Department of Energy
Washington, D.C. 20545

Docket No. 50-537
HQ:S:82:024

RESPONSES TO REQUEST FOR ADDITIONAL INFORMATION - CHEMICAL AND MECHANICAL
ENGINEERING

Question CS210.2

Figure 4.2-130. Thermal Stripping Evaluation Steps

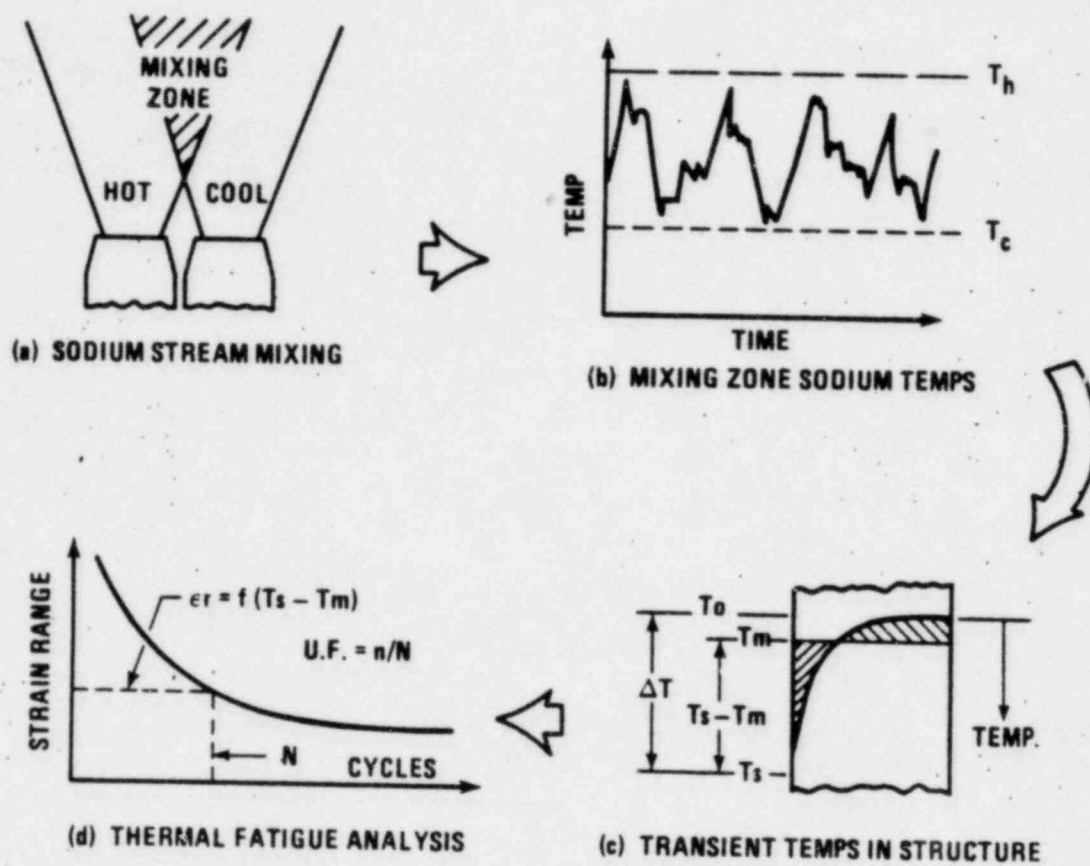
Describe methods and procedures used to evaluate the structural integrity at locations having savers thermal stripping effects.

The general method used to evaluate components for thermal striping is illustrated in Figure 4.2-130. The steps involved are as follows:

- a) The maximum potential for thermal striping is identified. This potential is the calculated temperature difference in sodium coolant from adjacent streams. Included in the temperature difference are 2σ uncertainties.

- b) Scale model tests are run as appropriate and the component thermal striping factors are measured. The measured striping factors are combined with the maximum striping potential to generate a thermal striping temperature time history and define a maximum fluid ΔT .

- c) The thermal striping temperature time history is used as the boundary temperature in a transient thermal analysis of selected component. This analysis calculates the magnitude of the fluctuating difference in the surface temperature and the mean temperature ($T_s - T_m$).

- d) The range of $T_s - T_m$ is used to determine a stress or strain range which is used in the fatigue evaluation of the structure.
